PUR-1378
ADDENDUM NO. 2
INVITATION TO BID

THE MARYLAND THEATRE EXPANSION
IN HAGERSOWN, MARYLAND

DATE: Monday, March 26, 2018

A-8.8
2/15/18
BID SET

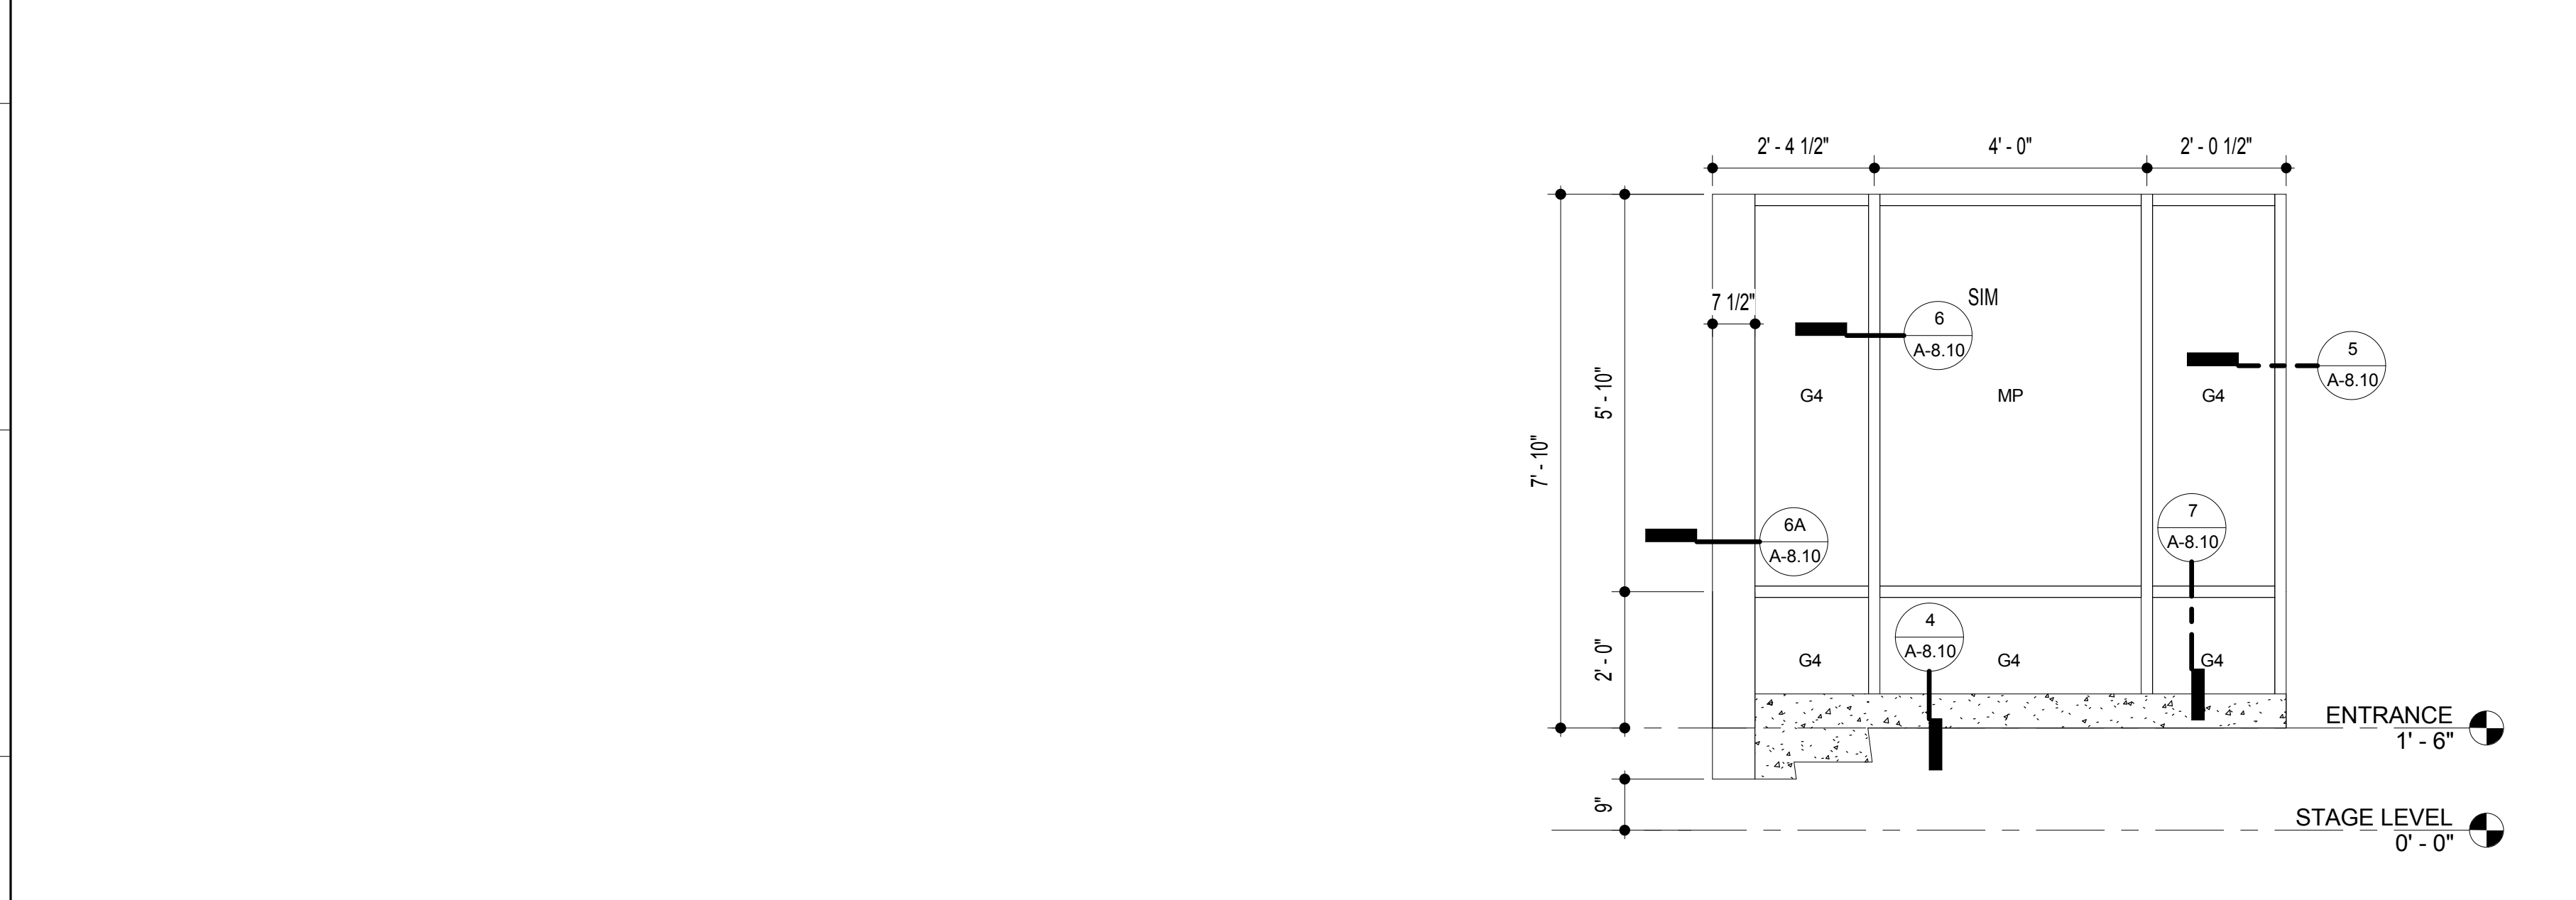
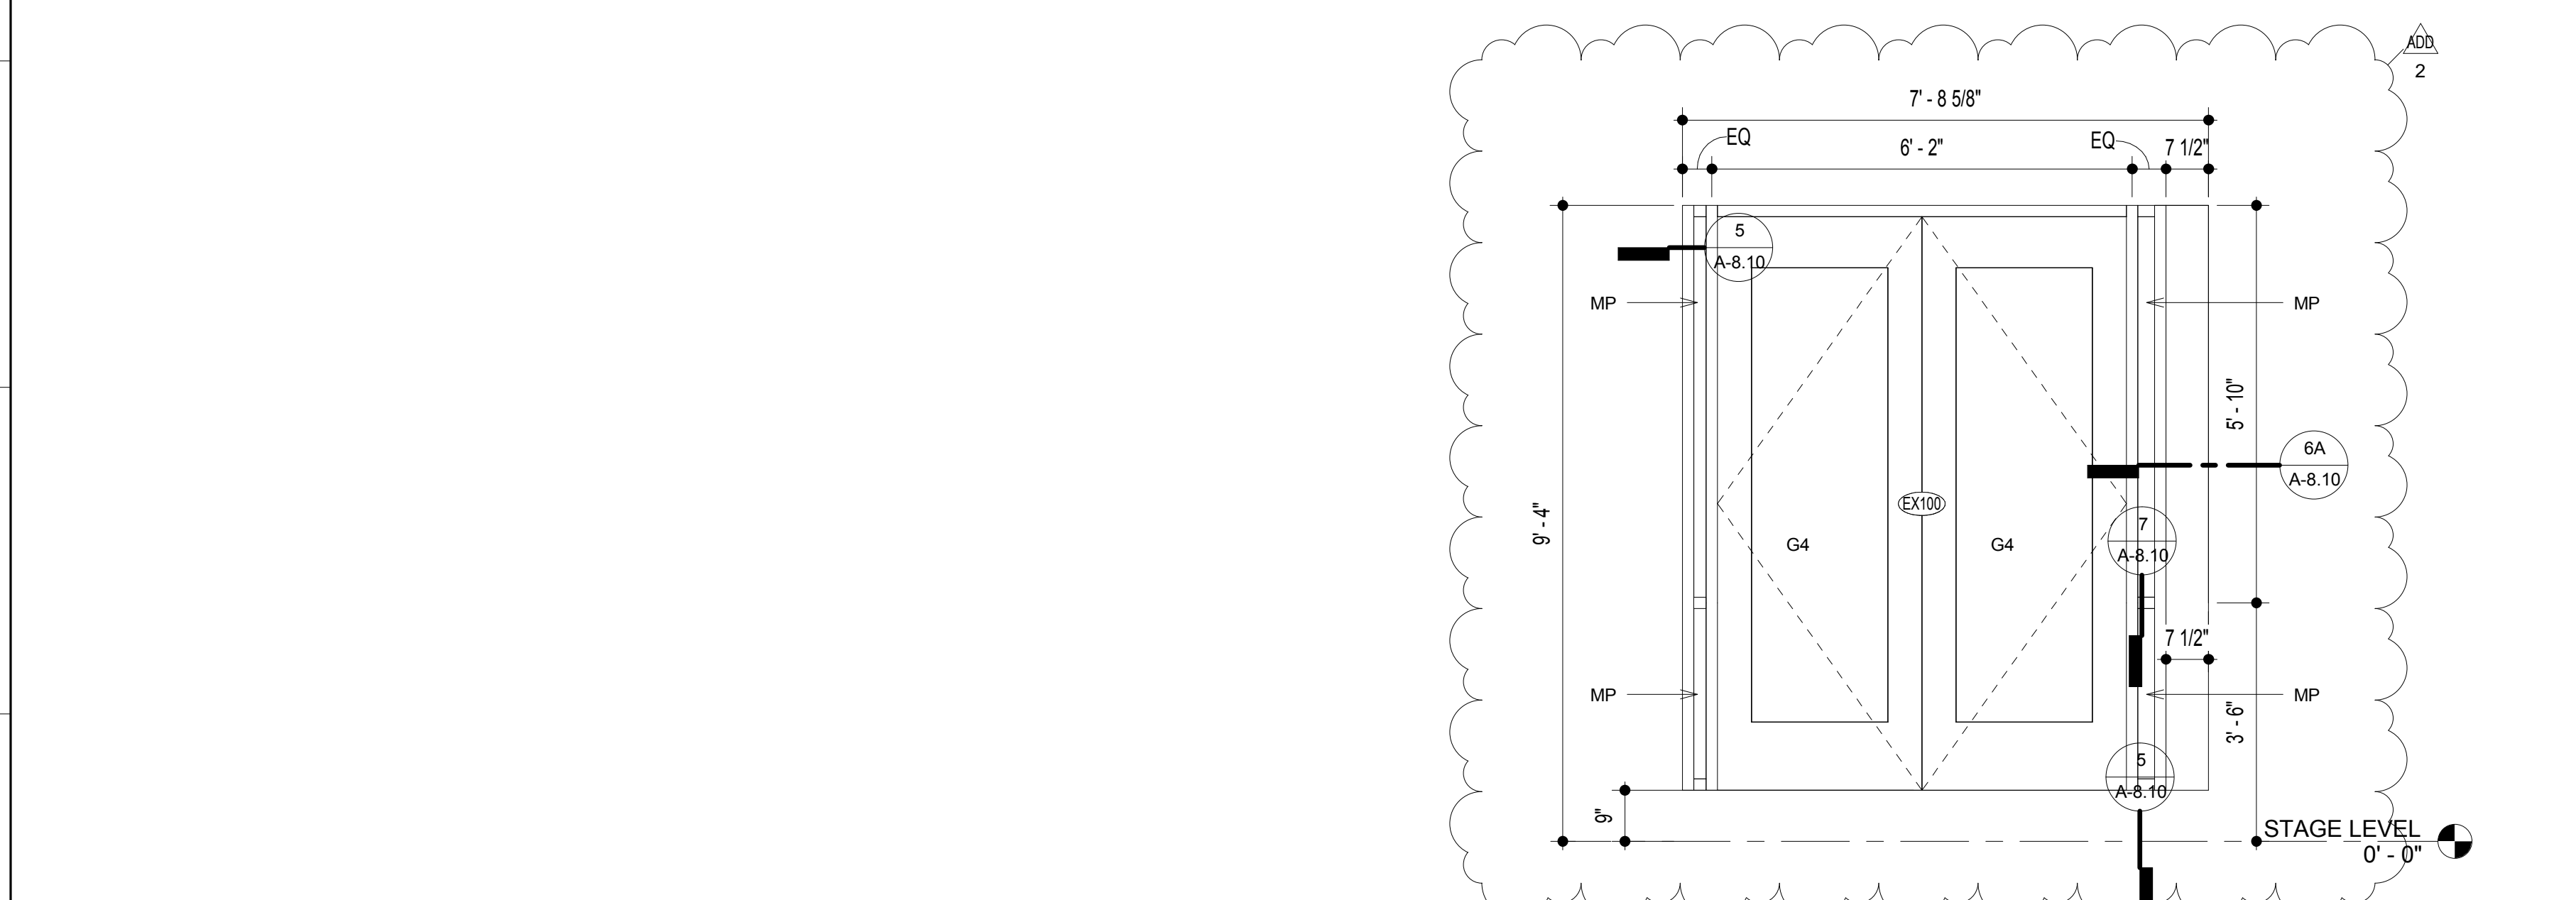
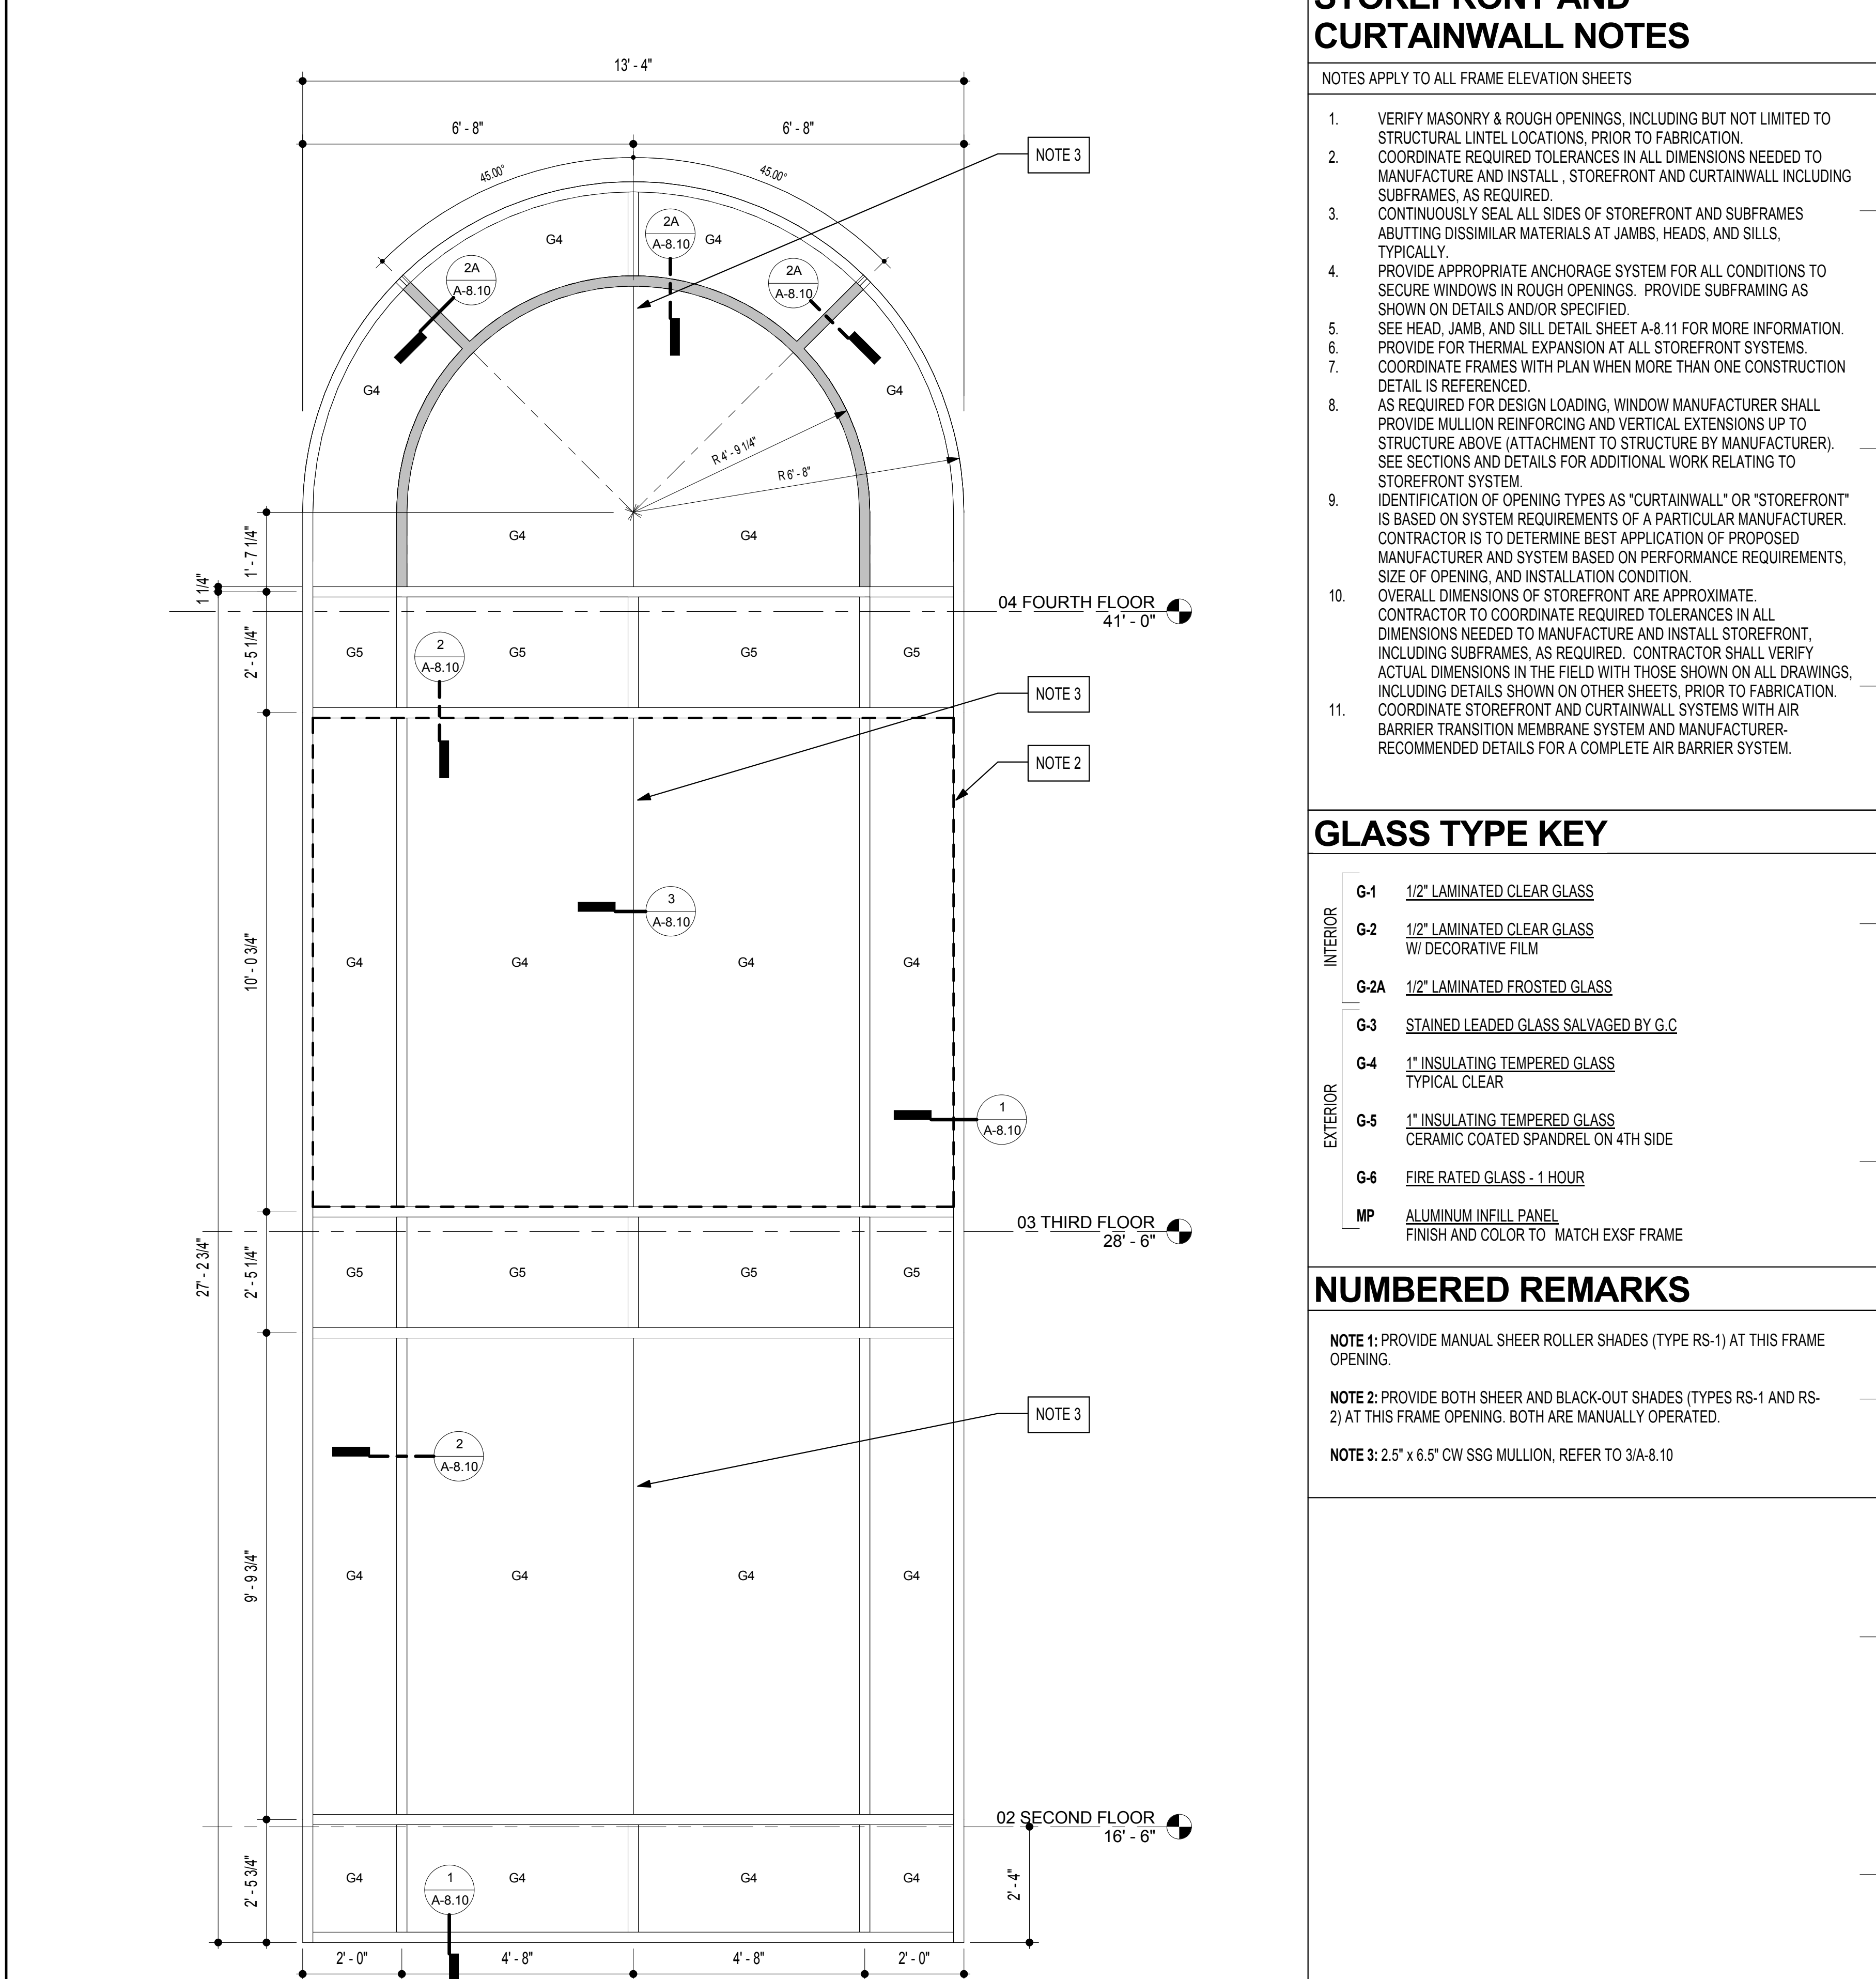
- REVISE** Revise door EX100 elevation to match sidewalk. Center Door in facade and replace sidelights with Metal Panels “MP” on sides.
- ITEM NO. 103** SHEET A-8.10– STAIR 1 PLANS AND SECTIONS *(SHEET ATTACHED)*
